Design Review Board

Tuesday, December 9, 2025

ZDRB-1125-000012 - 9135 Willeo Road - Chattahoochee Nature Center - Phase 2

SUBMITTAL SUMMARY REPORT (ZDRB-1025-000006) FOR CITY OF ROSWELL, GA

C200

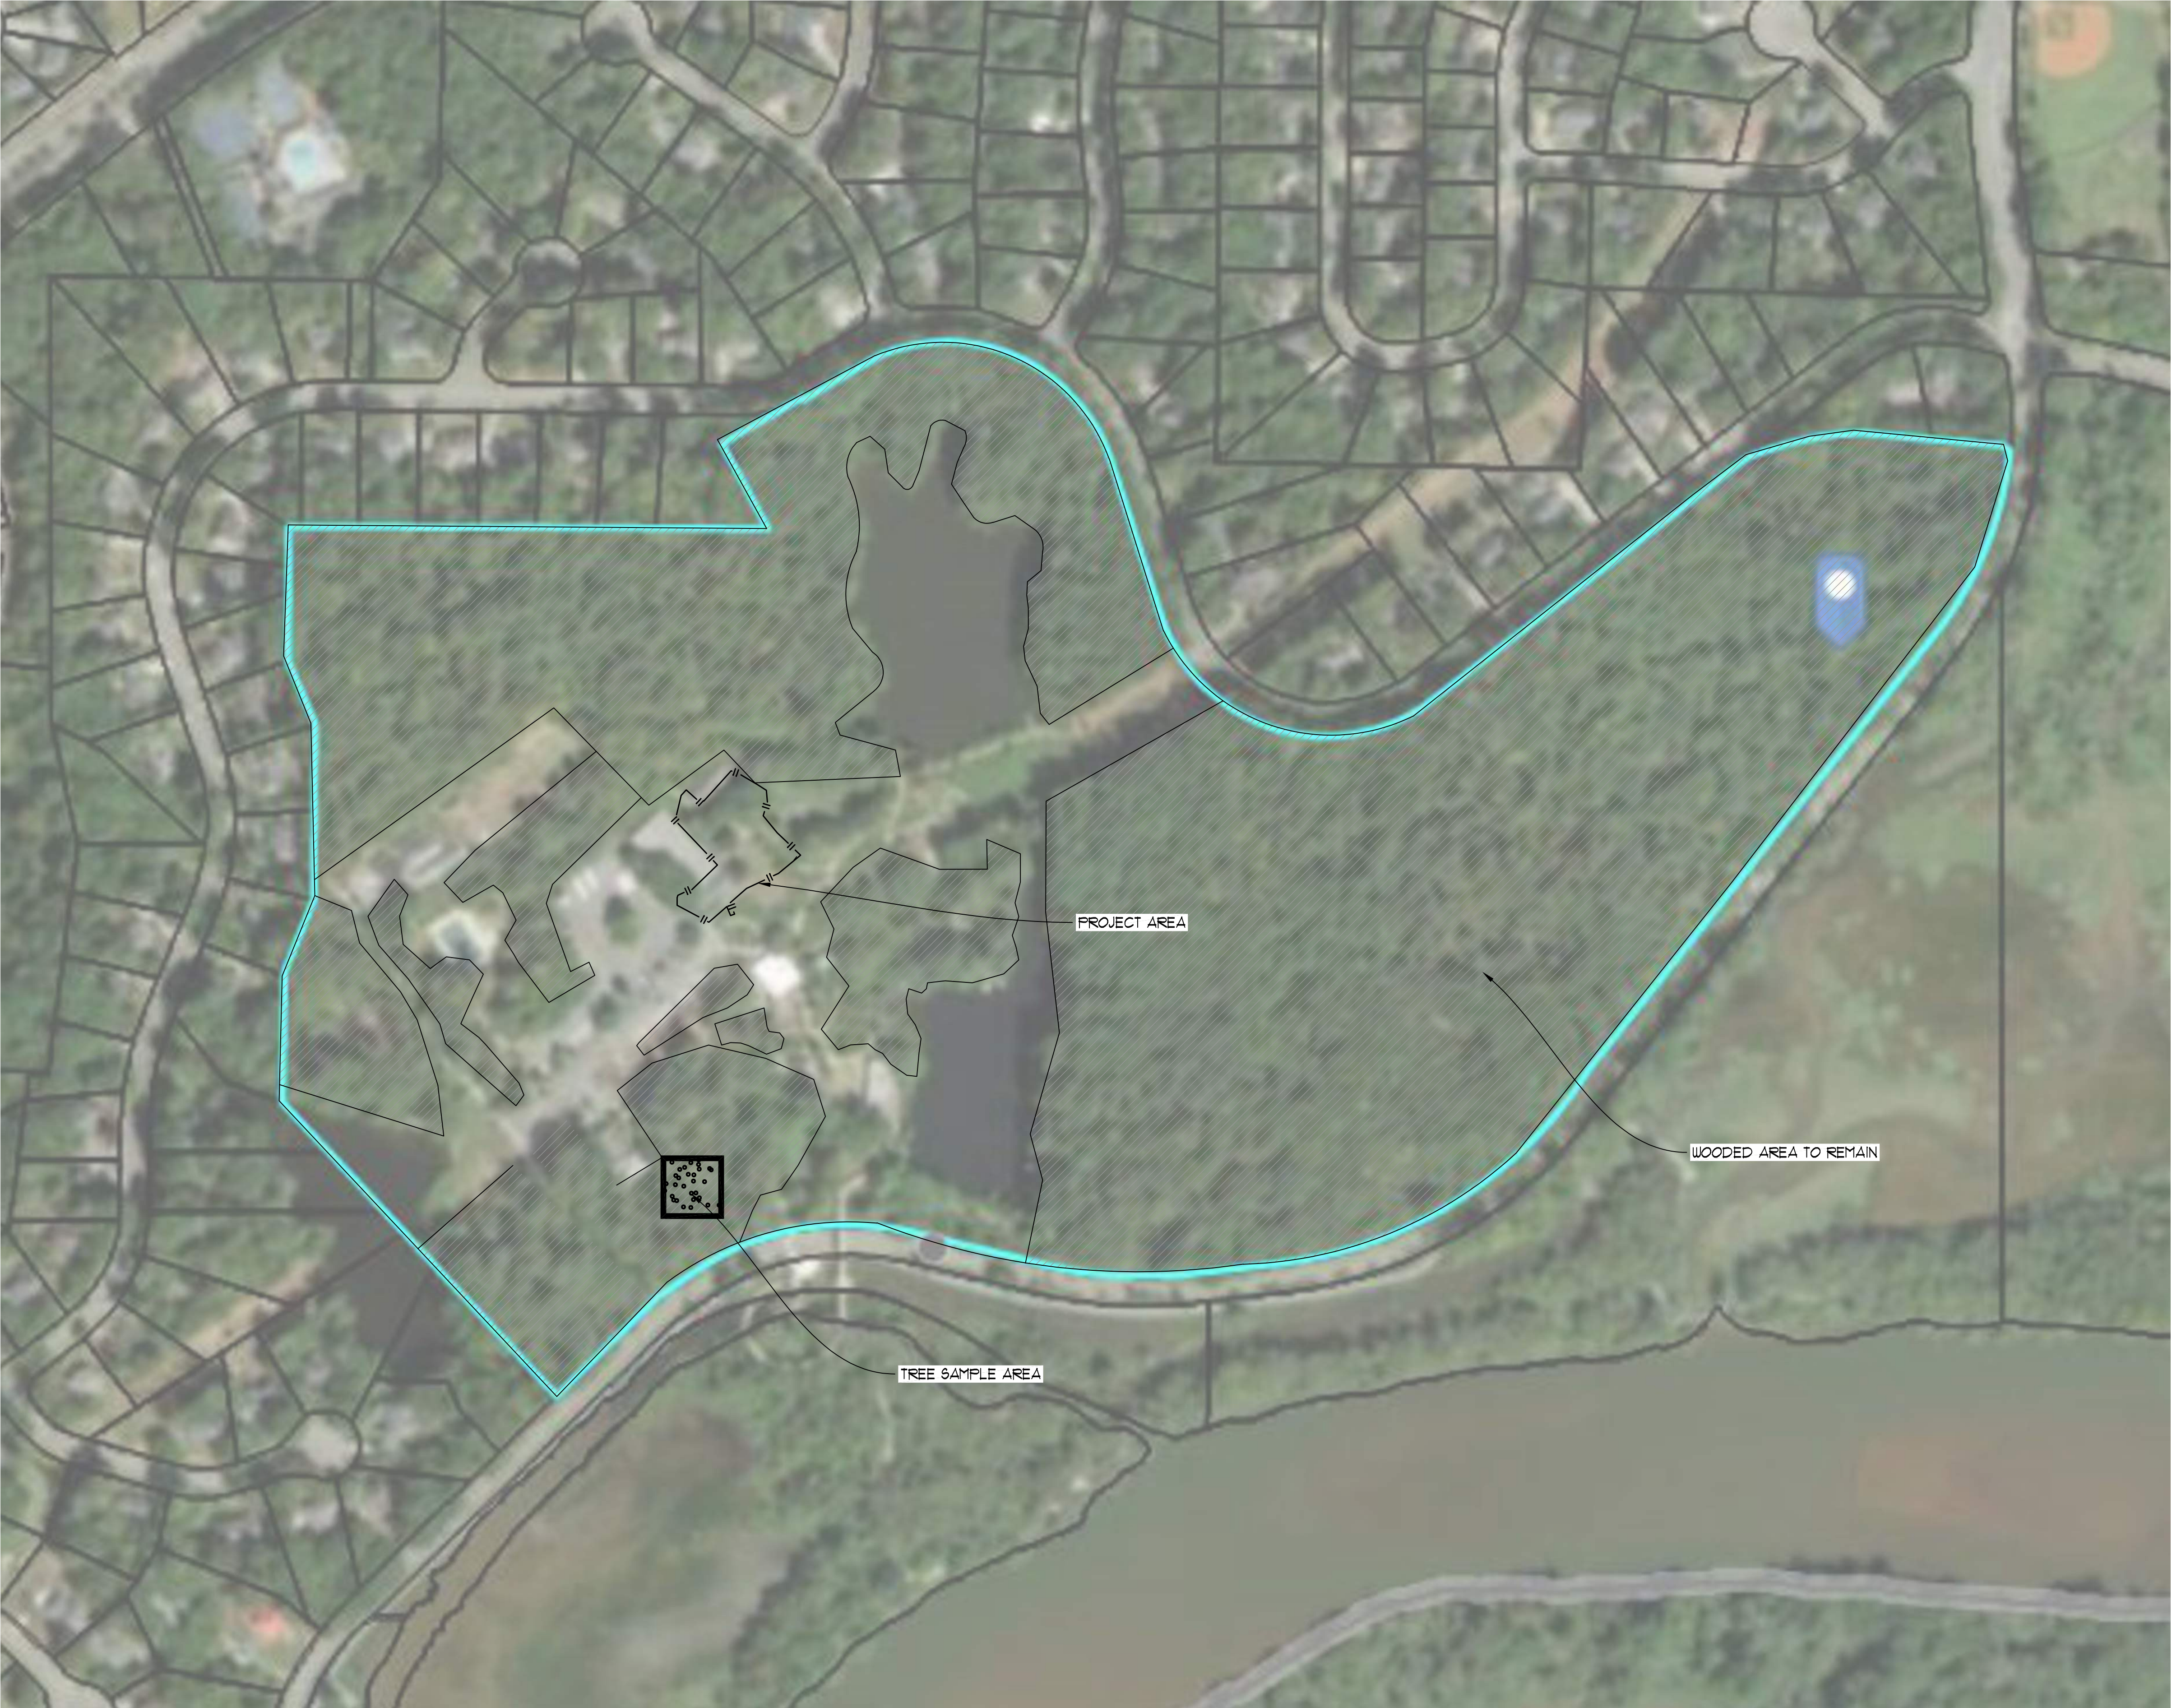
Corrections	General (Not Resolved) - Ensure site plan north arrow is referenced to State Plane Georgia West and state the same on the plan.			
Corrections	General (Not Resolved) - Clearly identify proposed limits of disturbance.			
Corrections	General (Not Resolved) - Show all parcel boundaries, right-of-way lines and/or easement lines located within the site plan viewport and call out range and bearing for each line segment.			
Corrections	General (Not Resolved) - Show proposed grading contours, or if no grading is proposed, state that on the plans.			
Corrections	General (Not Resolved) - Show at least two benchmarks or control points with coordinates referenced to State Plane Georgia West.			
Corrections	General (Not Resolved) - Provide a project location map inset on the site plan, showing sufficient information for the reviewer to understand where the site is located relative to at least one major intersection.

Corrections	General (Not Resolved) - Provide a topographical survey of existing conditions, including labeled elevation contours, parcel boundaries, and utilities both inside the project limits and immediately adjacent to the project limits.			
Fire (Fire)	Robert Major	11/17/2025	11/19/2025	Approved
Comments	<p>This approval is for DRB only. A building permit must be applied for and approved before any work can begin. Plans shall be submitted in accordance with the 2024 Life Safety Code for Fire Marshal's Office review. Plans reviewed by Robert Major rmajor@roswellgov.com 770-594-6263.</p> <p>The Roswell Fire Marshal's Office has reviewed the plans and specifications in accordance with the applicable state adopted minimum Fire Safety Standards in effect at the time of review. Every effort was made to check for code compliance. However, this does not relieve the owner, contractor, architect or any other responsible party from compliance with the items missed or unknown to the reviewer. Any changes or modifications in approved plans shall be reviewed by the City of Roswell prior to making the changes.</p>

ldadisman	(4) 4" caliper replacement trees = 3.6 TDU. Provide (10) more 4" caliper trees to meet specimen tree TDU removal of 12.6 (UDC Article 12.1.3.B.4) or provide and show specimen tree recompense calculations.	11/13/2025 3:30	PM251027 KF-RWC_DRB combined.pdf	
lsmith	CLARIFY WHETHER CONCRETE WALKS SHOWN ARE EXISTING OR PROPOSED	11/14/2025 8:34	PM251027 KF-RWC_DRB site plan.pdf	
lsmith	IDENTIFY UNLABELED FEATURES	11/14/2025 8:35	PM251027 KF-RWC_DRB site plan.pdf	
lsmith	IDENTIFY UNLABELED FEATURES	11/14/2025 8:54	PM251027 KF-RWC_DRB site plan.pdf	
lsmith	CLARIFY WHETHER GRAVEL DRIVE SHOWN IS EXISTING OR PROPOSED	11/14/2025 8:56	PM251027 KF-RWC_DRB site plan.pdf	
lsmith	IDENTIFY UNLABELED FEATURES	11/14/2025 9:00	PM251027 KF-RWC_DRB site plan.pdf	
lsmith	CLEARLY IDENTIFY PROPOSED LIMITS OF DISTURBANCE	11/14/2025 9:06	PM251027 KF-RWC_DRB site plan.pdf

1. Labels have been added to site plan.
2. Labels have been added to site plan identifying existing trees to be saved. Refer to Tree Protection Plan included with submittal for additional information and trees to be removed. Refer to Tree Replacement plan included with submittal for proposed trees to be planted.

3. Label added to site plan. Gravel drive is proposed (relocated from existing conditions)
4. Only one retaining wall is proposed at front of building. Max 3 ft tall. Labeled on site plan.

5. Note added under north arrow on site plan.
6. Limits of disturbance line is now shown on site plan (and labeled)
7. Parcel boundaries, R.O.W. lines are well outside of project area and not visible in viewport. (Refer to survey included in submittal). GA Power Easement is nearby and labeled on site plan

8. Refer to grading plan included with submittal.
9. Survey Benchmark now shown on site plan.
10. Location Map now included on site plan.
11. Refer to survey included with submittal.

TREE PROTECTION PLAN

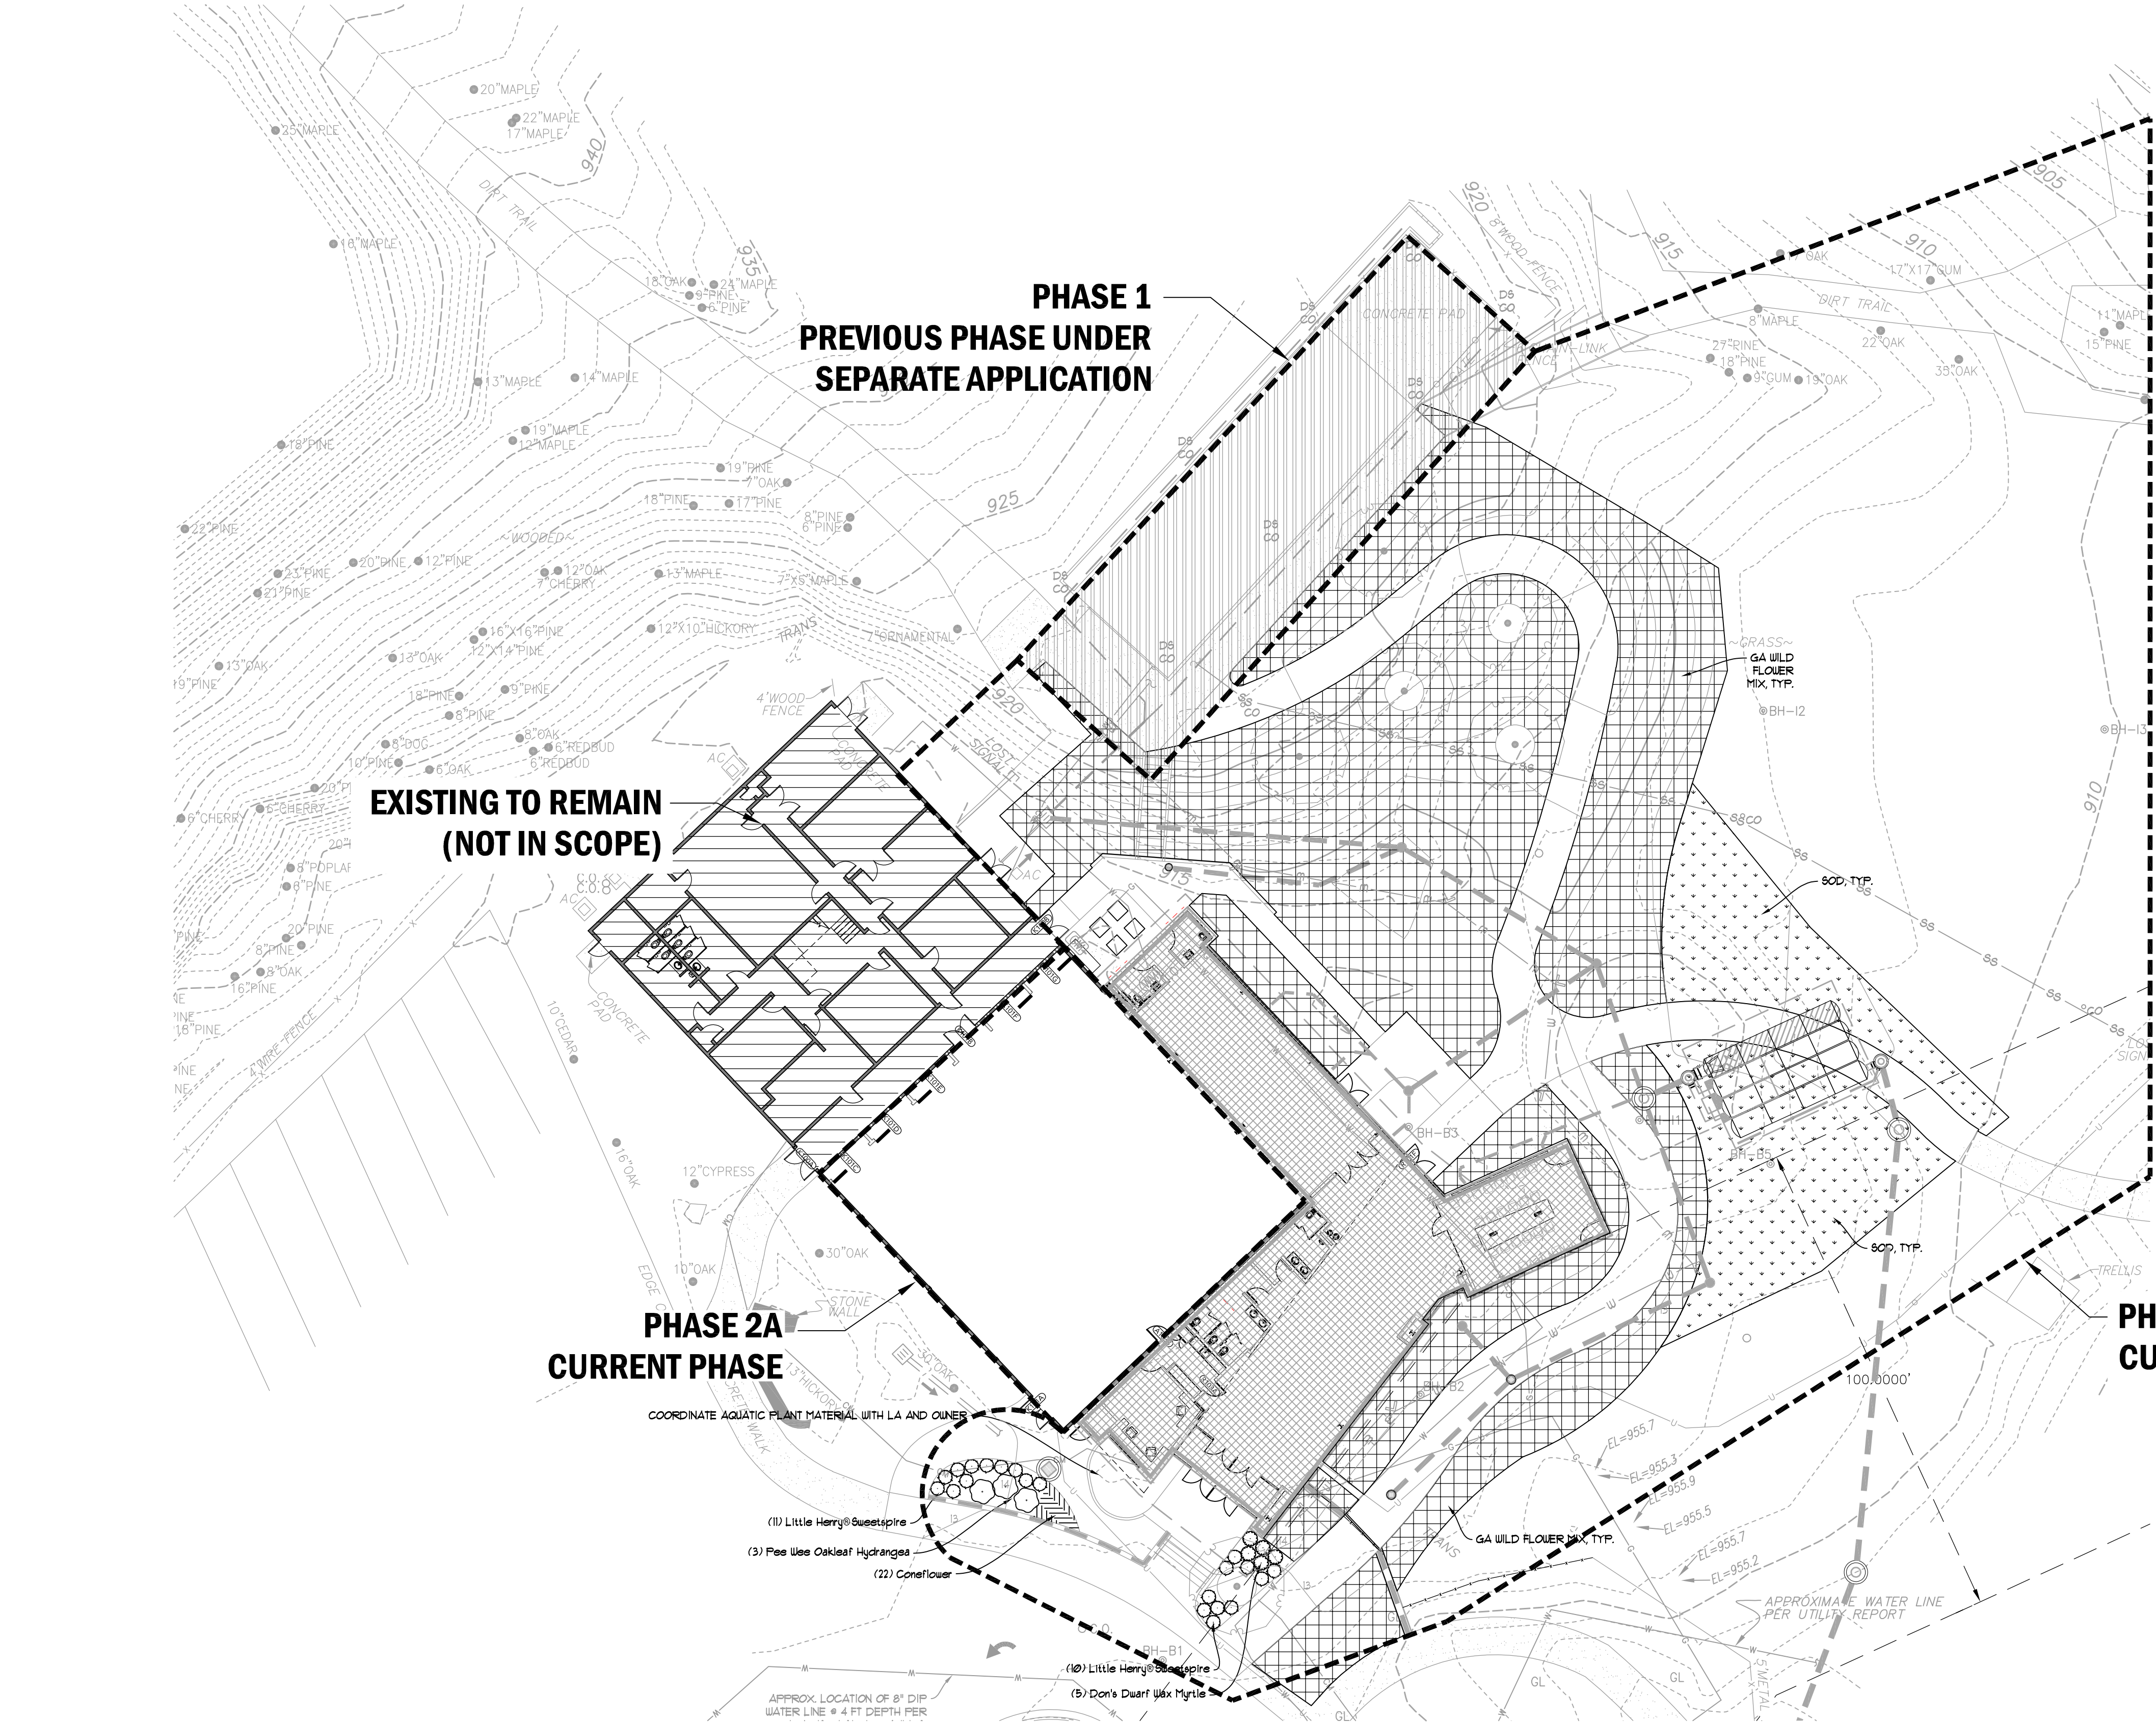
Transportation (Transportation)	Serge Osse	11/17/2025	11/13/2025	Approved with Comments
Comments	No comment. (Streetscape along the river, opposite side of this site, is already in place)			
Tree (Tree)	Laura Sommet	11/17/2025	11/13/2025	Requires Re-submit
Comments	See corrections and plan markups - On the Tree Protection Plan and Tree Replacement Plan, please show the 'TP' tree protection fence on the plans. For the specimen tree removal table shown, this shows replacement inches not TDU. 4" cal trees = 1.5 TDU. Therefore, (4) x 1.5 TDU = 6 TDU. Still need at least 6.6 TDU or (5) more 4" caliper trees to meet specimen tree TDU removal (UDC Article 12.1.3.B.4) or provide and show specimen tree recompense calculations.			
Corrections	General (Not Resolved) - See corrections and plan markups - On the Tree Protection Plan and Tree Replacement Plan, please show the 'TP' tree protection fence on the plans. Revise the specimen tree removal table. It shows replacement inches not TDU. 4" caliper replacement trees = 0.9 TDU. Therefore, (4) x 0.9 TDU = 3.6 TDU. Still need at least 9 TDU or (10) more 4" caliper trees, example, to meet specimen tree TDU removal (UDC Article 12.1.3.B.4 and 12.1.6.) or provide and show specimen tree recompense calculations.

1. TP fencing is now shown and labeled on plans
2. Specimen tree calculations have been updated
